Access Compliance Report

Public Rights-of-Way

(Curb Ramps)

Intersection ID: 15089	Main Street: FAIRWOOD_AV	Cross Street: YOUNGBLOOD_ST	Location: N
ADA ID: 5EEBE28BE81B	Ramp Type: PerpDiag	Initial Pass/Fail: Fail	Overall Compliance: No
			Severity Score: 13.75

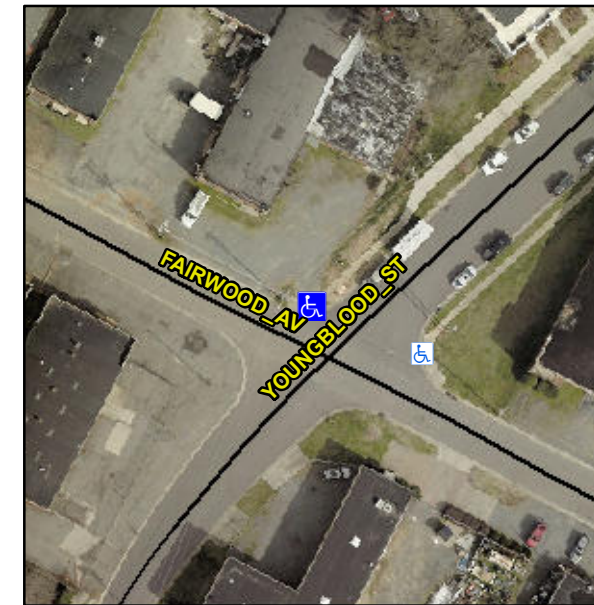
Not Found, R304.2.2, R304.5.3

Remove & Replace Curb Ramp With Two New Directional Ramps or Equivalent.
